Friday, February 28, 2003  
Document Control Desk  
U.S. Nuclear Regulatory Commission  
Washington, D.C. 20555

Ref: Docket 50-27

This letter is a response to a U.S. Nuclear Regulatory Commission request for additional information dated January 9, 2003.

Figure: Pressure Sensor Positions Relative to the "Absolute Filter"

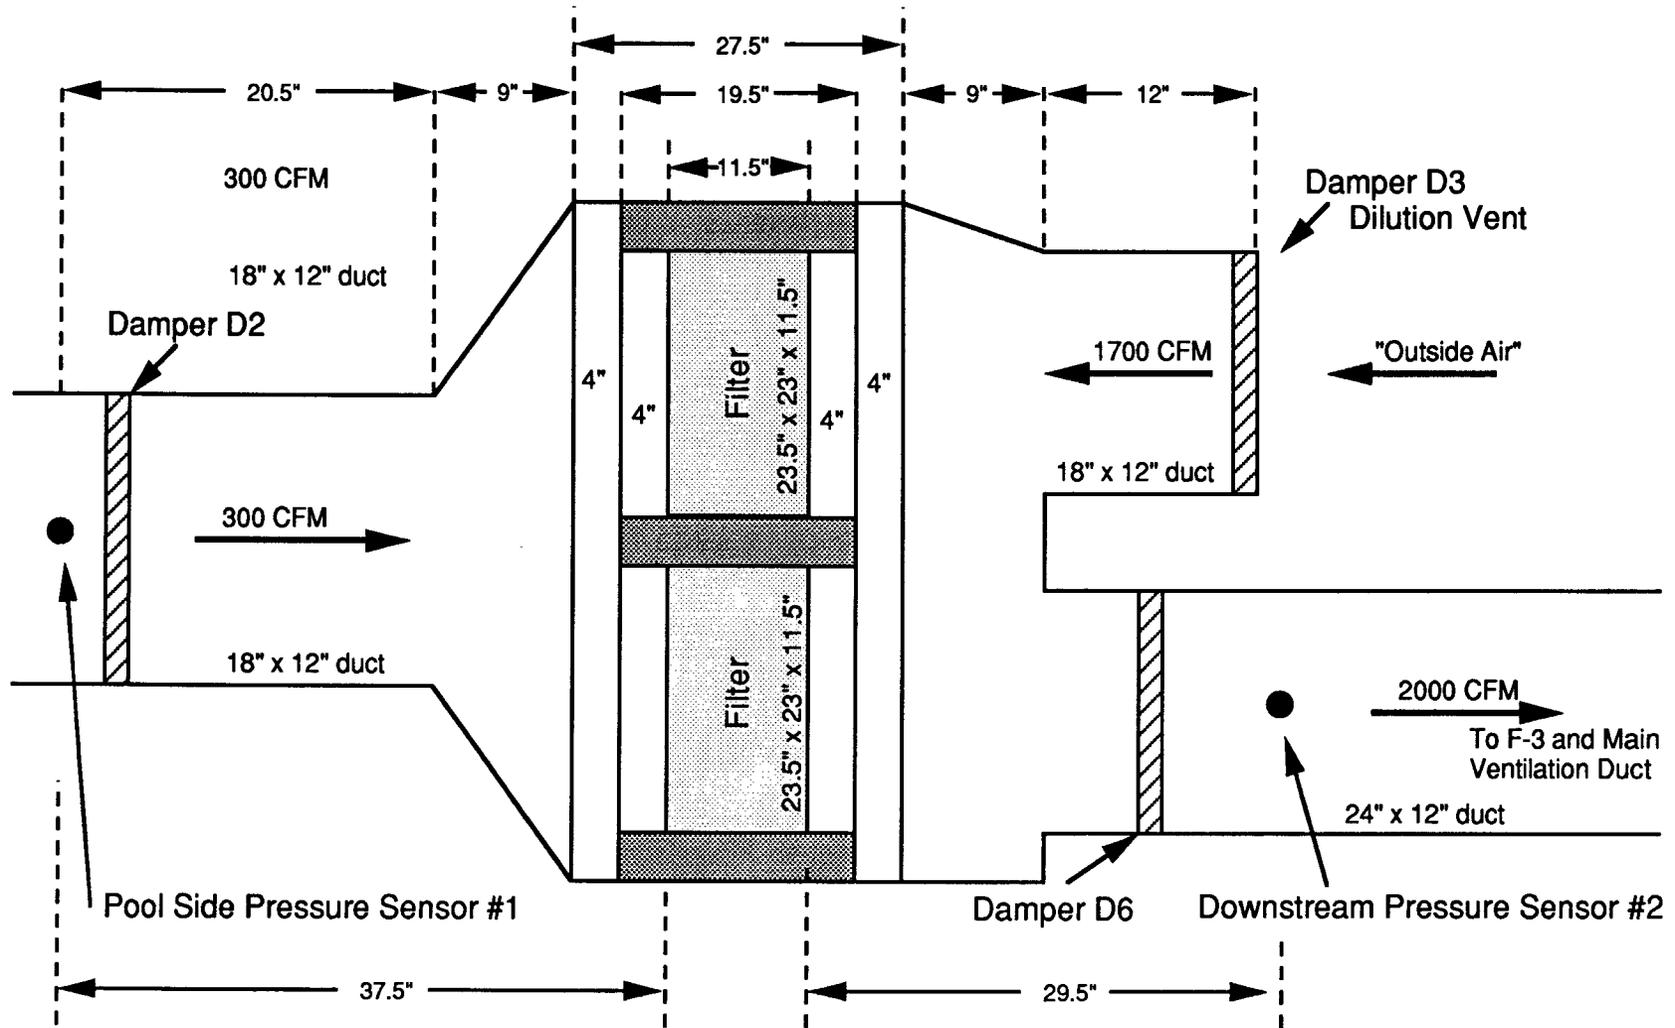
1. According to your request to change the Technical Specifications (Amendment No. 18) the new criterion to replace the "absolute filter" will be based purely in the performance of the filter. The pressure drop caused by the "absolute filter" will be the only indicator to ensure that the filter performance is acceptable. Figures 9-1 and 9-2 of the Safety Analysis Report are inconsistent on where the Pressure Elements (PE) are installed with respect to the "absolute filter." Please provide a detailed diagram of the installation of the two pressure elements used to calculate the pressure drop caused by the "absolute filter." This diagram should illustrate the section of the HVAC system that is used in the "dilute mode." The following detailed information should be included with this illustration:

- (a) duct dimensions where the "absolute filter", the first pressure element, and second pressure element are installed, and
- (b) the distances between the two pressure elements and the "absolute filter."

Attached is a more detailed diagram entitled, "Pressure Sensor Positions Relative to the 'Absolute Filter'". On this diagram one can see the position of the pressure sensor on the pool side of the absolute filter. In the dilute mode, 300 CFM is being drawn from the pool room. It then passes the first pressure sensor located 37 1/2" upstream of the absolute filter. The filter consists of two side by side box shaped objects of dimension 23 1/2" x 23 1/2" x 11 1/2" oriented as shown. The second pressure sensor in the diagram is located 29 1/2" downstream of the absolute filter in the duct leading to the main ventilation system exhaust. In the dilute mode, 300 CFM of pool room air is passed through the HEPA filter and then mixed with 1700 CFM of "outside air" to produce a "dilution" factor of 6.67 when the filter is new. If the HEPA filter becomes slightly obstructed

through use, the dilution factor would become larger and therefore the radioactive air release rate would become more conservative. After dilution, the mixed air passes through damper D-6 and enters fan F-3 which draws the air into the main ventilation duct where the "Exhaust Gas Monitor" measures the Argon-41 release. The total distance between the two pressure sensors is 78.5".

**Alpha Cell HEPA Filter Dimensions and Capacities**

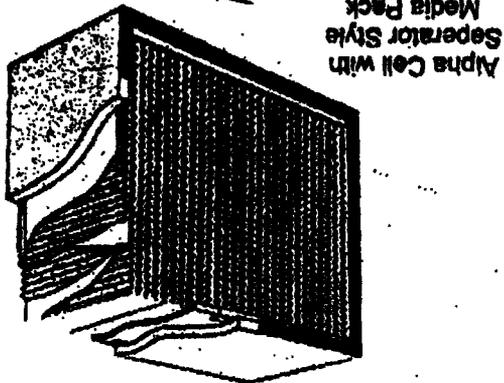
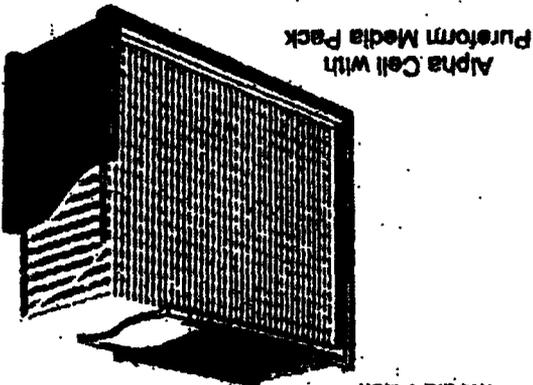
2. Please provide information on how you are planning to calculate the flow across the absolute filter to ensure that the filter is performing between the limits of pressure drop and volumetric flow specified by the TSs. Please provide an original-copy of the performance chart of the "absolute filter" provided by the manufacturer.

It was not our intension to re-calculate the flow across the absolute filter. Measurements of flow rates were made when the system was installed to validate the design. We could arrange to have the flow rates verified again but only if the US NRC considers it to be essential. We do not consider it relevant because if the "absolute filter" became more obstructed with use, the flow through it would be slightly reduced. A flow reduction through this filter would increase the dilution factor, making its performance more conservative than the less obstructed "new" filter.

Please find attached a FAX sent to us by the manufacturer of the "absolute filter" designated YY-F. It is the third row from the top in the CFM Capacities and Dimensions table.
